Open Water Surf Facility Modification 1

State Significant Development Modification Assessment
(SSD 7942 MOD 1)

February 2022

Figure 2 | Comparison of approved building footprint (left) and proposed (right) (base source: Modification Report)

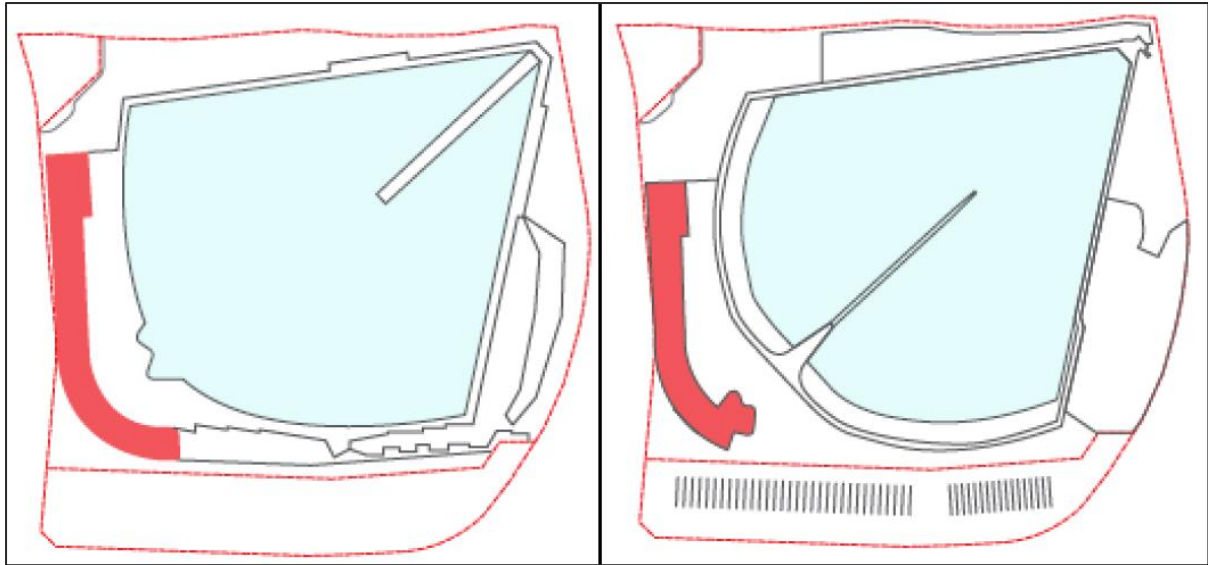
Element	Elements of proposal as amended
Built form	<ul style="list-style-type: none"> consolidate the building footprint by 260 m², from 1,570 m² to 1,310 m² (Figure 2), by providing a predominately two-storey building with a three-storey element increase GFA by 301 m², from 1,715 m² to 2,016 m² by predominately: <ul style="list-style-type: none"> decreasing GFA on the ground floor by reducing the GFA for the surf academy and amenities, and relocating staff offices and administration areas to the first floor increasing GFA on the first floor, by adding an office and management space with a control room, amenities, meeting rooms and a multi-purpose space for events decrease the maximum building height by 0.5 m (from 12.8 m to 12.3 m) and amend finished floor levels (Figure 3): <ul style="list-style-type: none"> lower ground: from RL 5.00 to RL 6.15 ground floor: from RL 9.00 to RL 9.40 first floor: from RL 12.6 to RL 13.15 ridge: from RL 17.8 to RL 18.65.

The Department considers the modified built form of the building to be modest and appropriate noting it would be predominately two storeys high and would cover 3.5% of the total site area compared to 4% for the approved development.

Figure 4 | The approved site layout (top) and proposed (bottom) (base source: Modification Report)

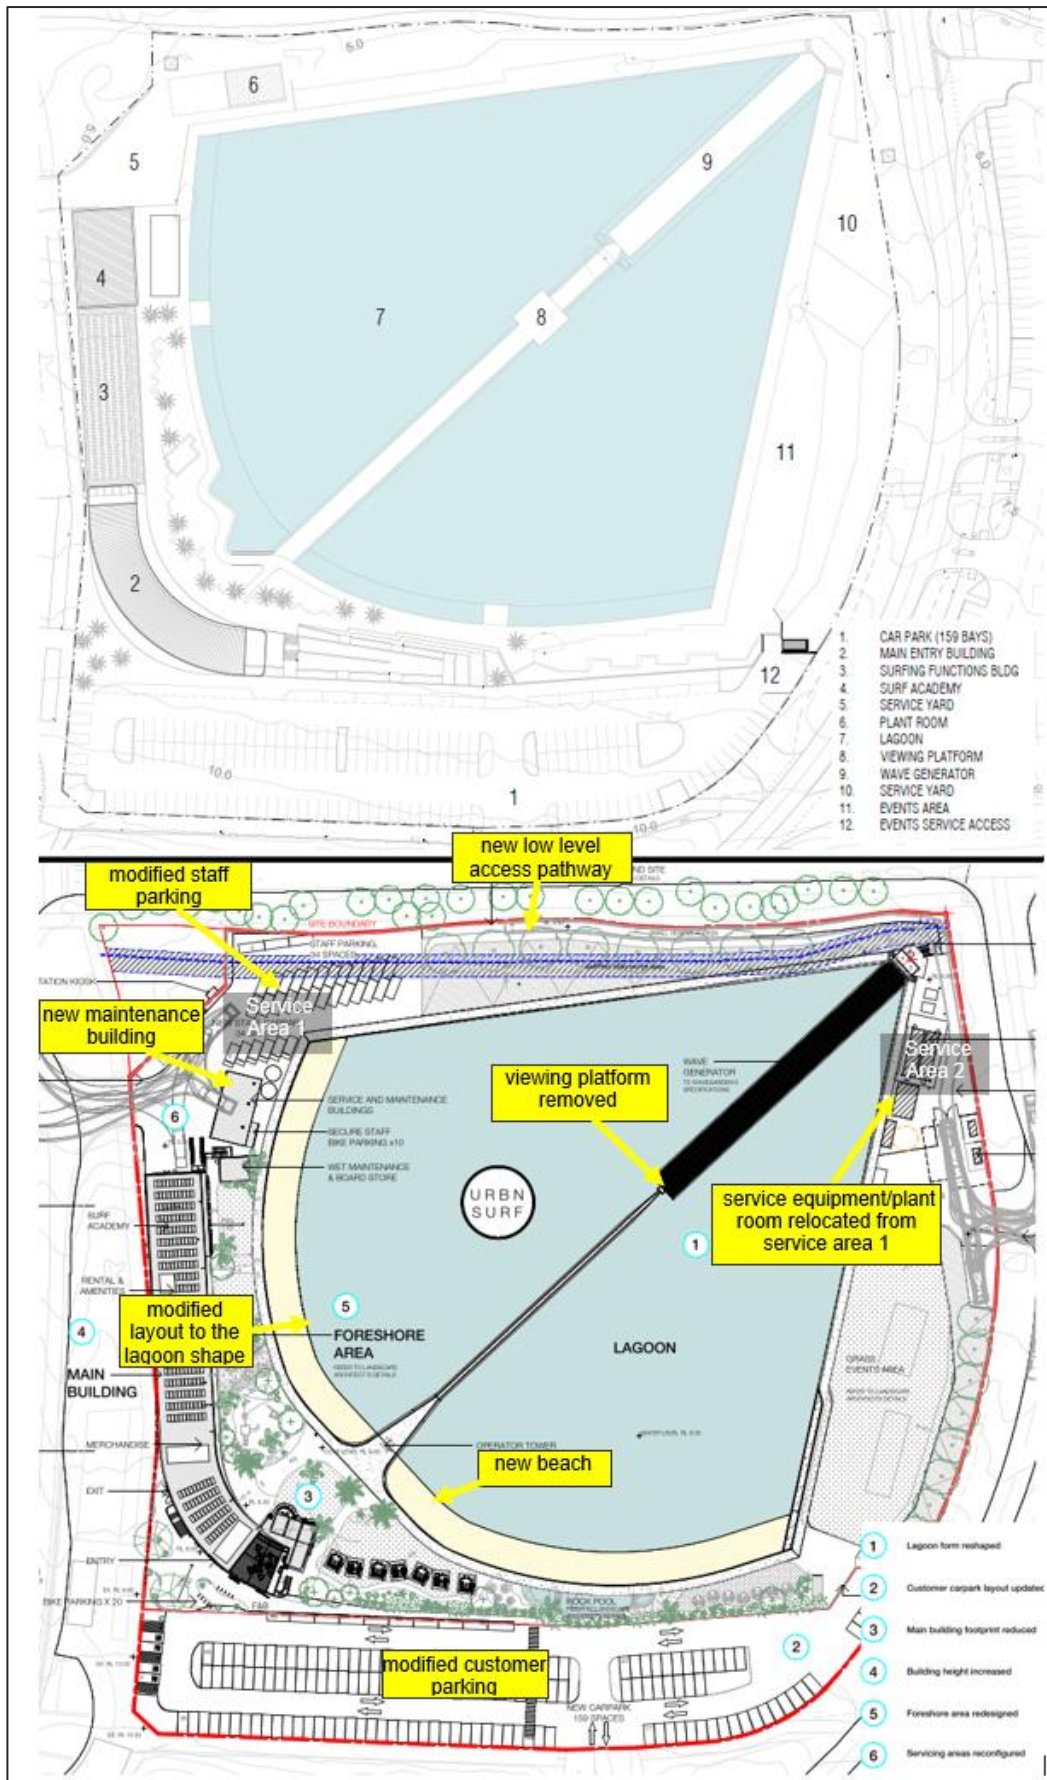
Lagoon and adjacent facilities	<p>Modify the layout of the lagoon and adjacent facilities (Figure 4) including:</p> <ul style="list-style-type: none"> add a beach along the entrance to the lagoon extend the foreshore area at the centre of the lagoon and erection of an operator tower remove the central viewing platform add a low-level access pathway along the Hill Road boundary connecting service area 1 and service area 2. relocate workshop/storage area within the basement to a standalone building within service area 1 relocate service equipment/plant room from service area 1 to service area 2 amend the lighting design for the lagoon by providing six, 30 m high lighting towers instead of five, 25 m lighting towers.
Building layout	<p>Modify the layout of the building including:</p> <p><u>Basement/lower level:</u></p> <ul style="list-style-type: none"> reconfigure the service area add a food and beverage storage area relocate lift and stairway <p><u>Ground floor (Figure 5):</u></p> <ul style="list-style-type: none"> reconfigure the surf academy space and relocate the first aid room relocate and reconfigure the rental area and storeroom

Figure 5 | The approved ground floor plan and (top) and proposed (bottom) (base source: Modification Report)

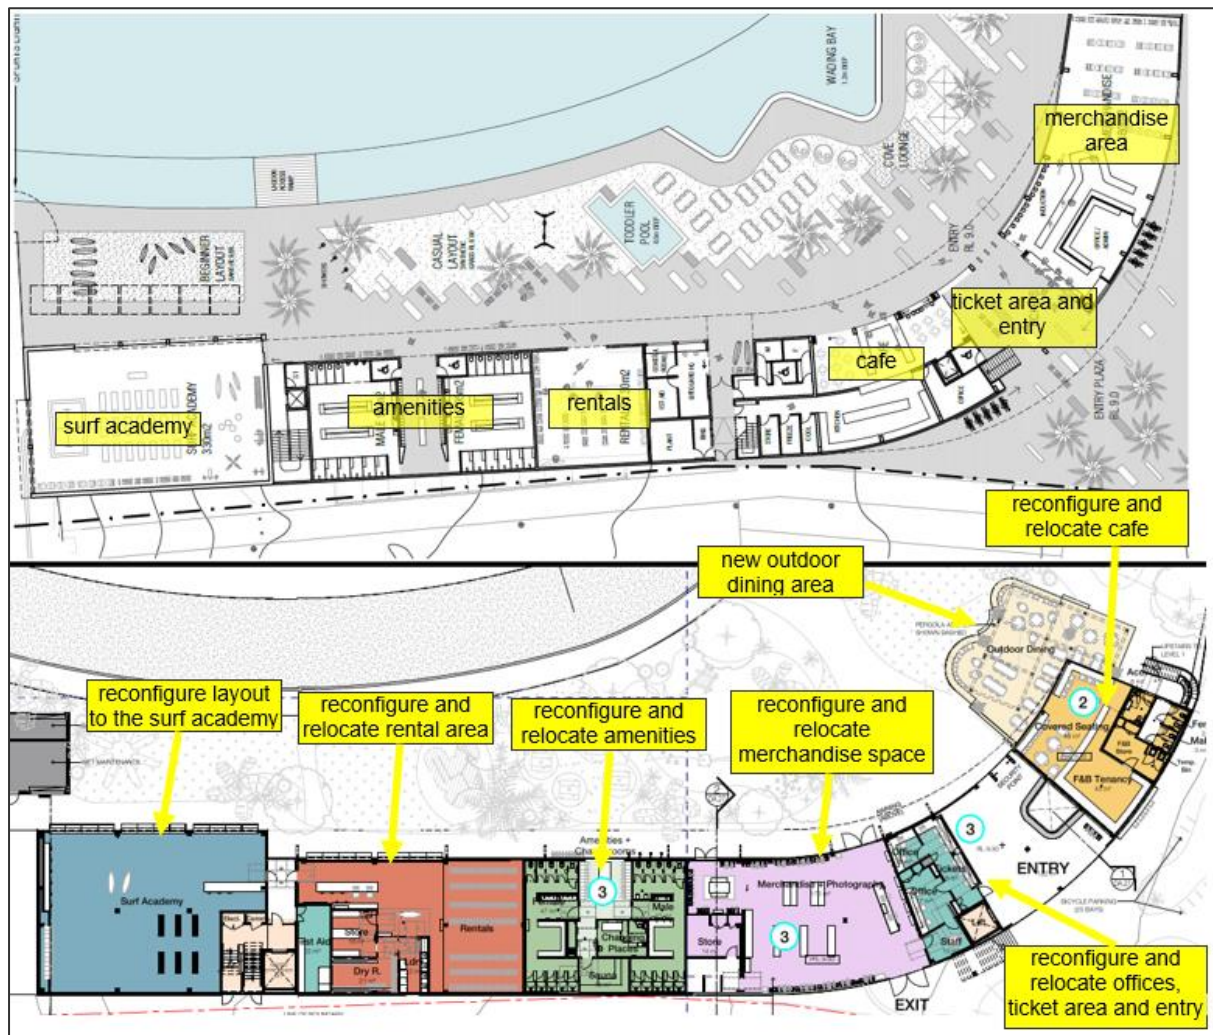
- The proposal seeks approval to amend the internal layout of the building (**Figures 5 to 7**).
- The Applicant advised the changes have primarily arisen from design development and a greater understanding of operational requirements following the opening of the Melbourne Surf Park.
- The Applicant provided a BCA and Access Statement which concluded the revised design was capable of achieving compliance with the requirements of the BCA and relevant requirements for the provision of access for persons with disability.
- The Department is satisfied the proposed modification would not result in any significant environmental impacts and therefore concludes the changes are acceptable.

The Department recommends Condition A2 is updated to reflect the revised design drawings.

Figure 6 | The approved first floor plan and (top) and proposed (bottom) (base source: Modification Report)

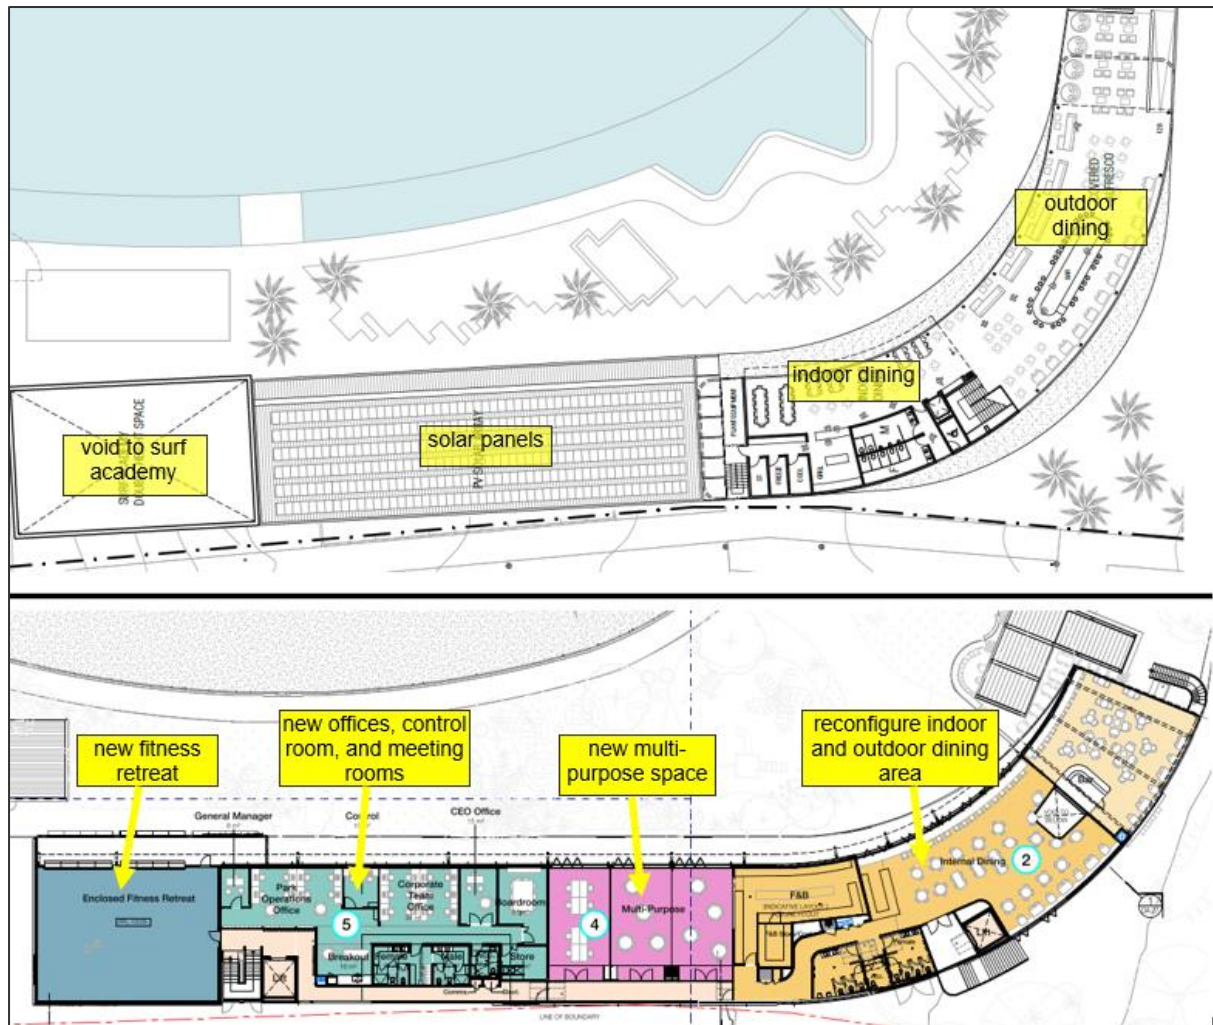
First floor (Figure 6):

- add an office and management space with control room, amenities, meeting rooms and lift access
- add a multi-purpose space for events
- reconfigure the food and beverage area, kitchen, storeroom, bar, amenities, internal dining and alfresco dining
- amend the surf academy space to single storey and add a fitness retreat room
- relocate photovoltaic panels to the roof.

Figure 7 | The approved landscape plan (top) and proposed (bottom) (base source: RTS)

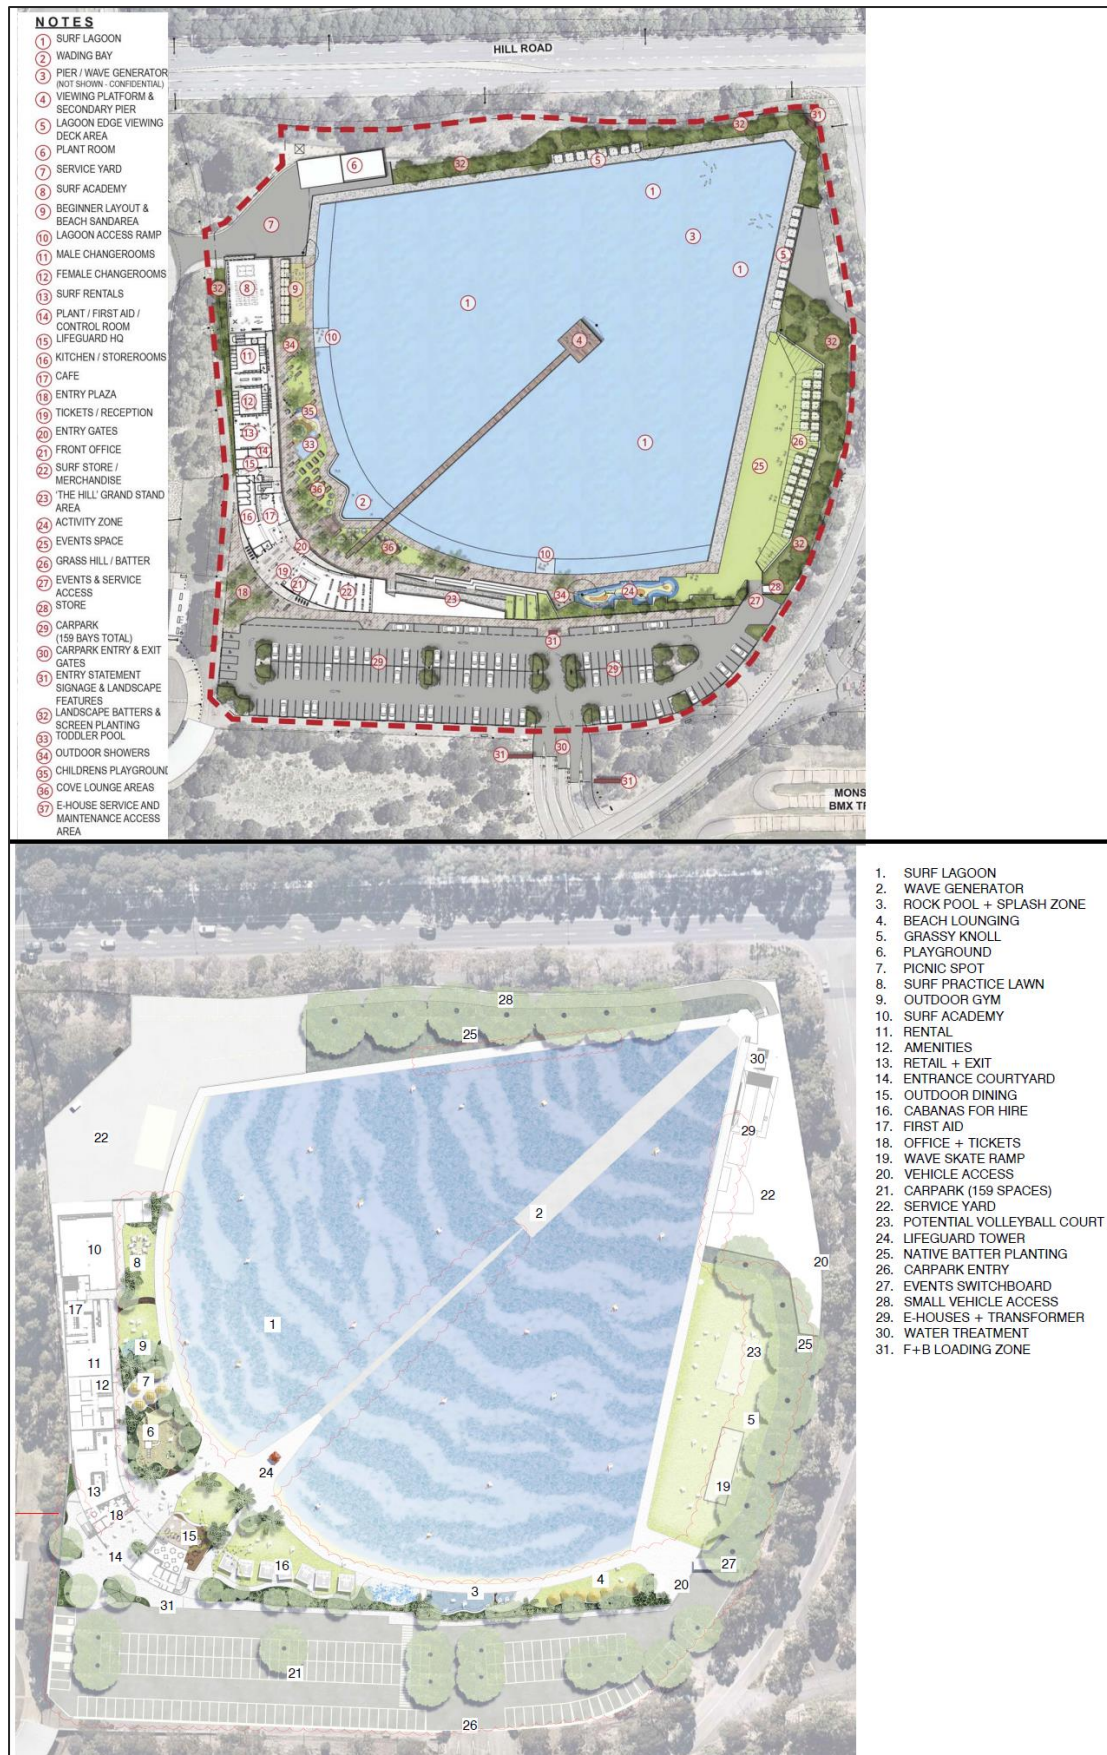
- modify the landscape to be consistent with the amended built form and amended shape of the lagoon (Figure 7)
- rearrange/relocate lagoon side features, including toddler splash pool, outdoor fitness equipment, children's playground and cabanas
- remove eight trees within the public parking area.

The Department recommends amending Condition A2 and Condition B6 to reference the revised landscaping plan.

Figure 10 | The approved materials and finishes (top) and proposed (bottom) (base source: Modification Report)

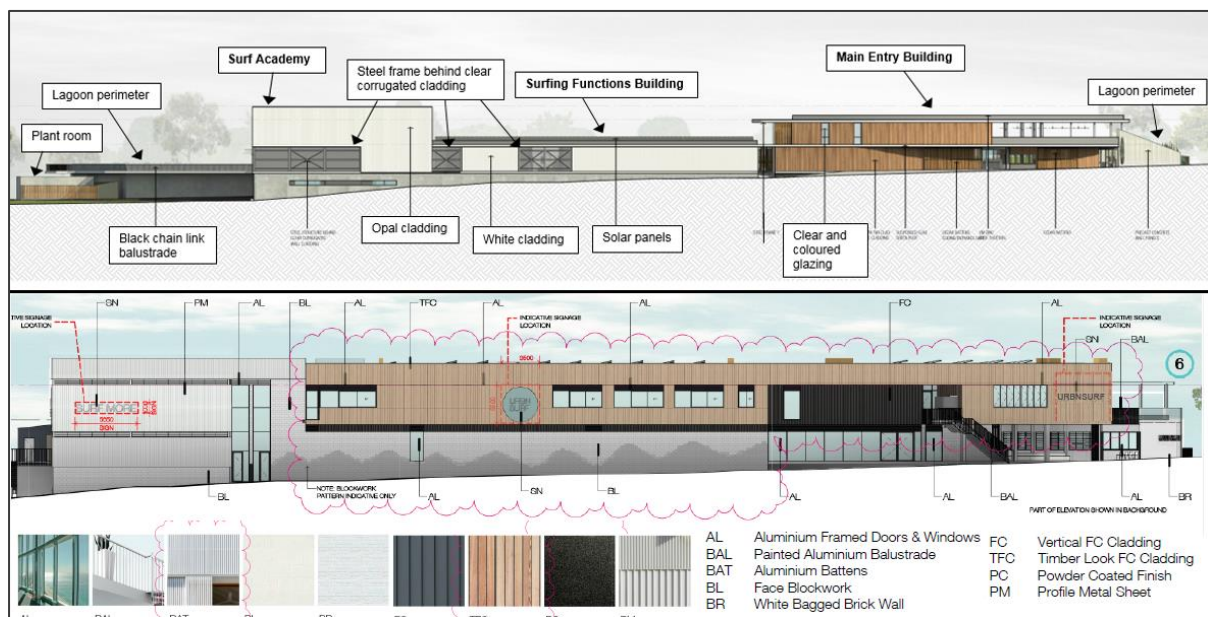
The Applicant contends the amendments to materials and colours is a result of design development and the BCA requirement for use of non-combustible material. The natural cedar wall cladding is therefore proposed to be replaced with a combination of non-combustible timber fibre cement cladding, white battens and white bagged brick wall for the main entry building and along the first story of the building. The blockwork includes an indicative wave pattern. The remainder of the building will use a combination of light-coloured face blockwork and sheet wall cladding.

A comparison of the approved materials and proposed materials is provided in **Figure 10**.

The Department considers the proposed changes to the materials and colours of the façade acceptable as the colours and materials will continue to provide visual interest to the streetscape and is appropriate for the site and its surrounds.

Figure 11 | Light spill on the Narawang wetland (source: LIA)

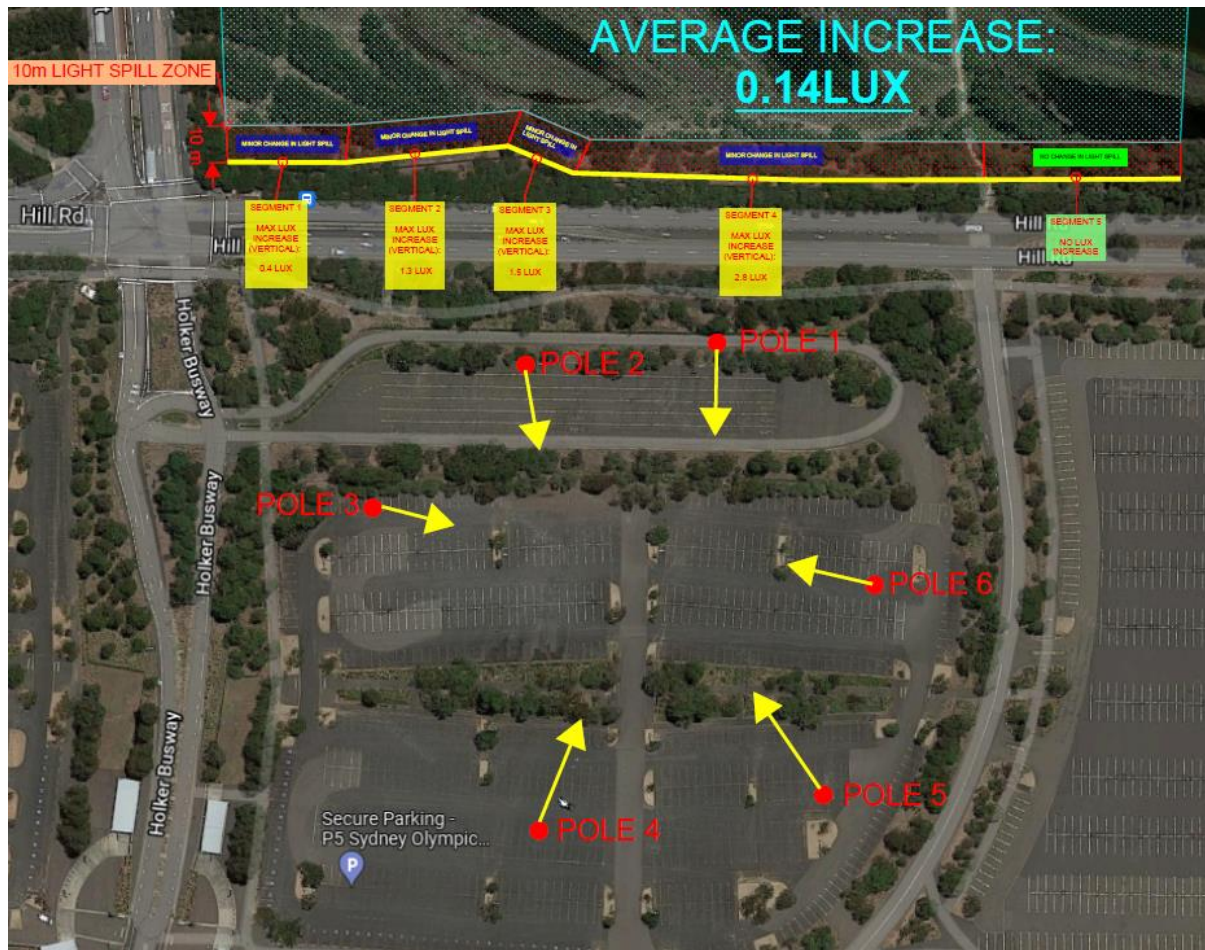
The location of greatest light spill is to Narawang Wetlands located to the north of the site. The LIA concludes that the proposed additional lighting expected at the boundary to the wetland ranges from 0 to 2.8 lux, while the proposed lighting level past the wetland boundary is 0.25 lux, an average increase of 0.14 lux over the existing scenario (**Figure 11**). The increase in lux levels are not perceivable without the use of sensitive measuring equipment.

The proposal would result in up to one-hour potential light spill impact during the morning (of the shortest day in winter), seven-days-a-week, and an additional two hours of potential light spill impact during the evening on Fridays and Saturdays.
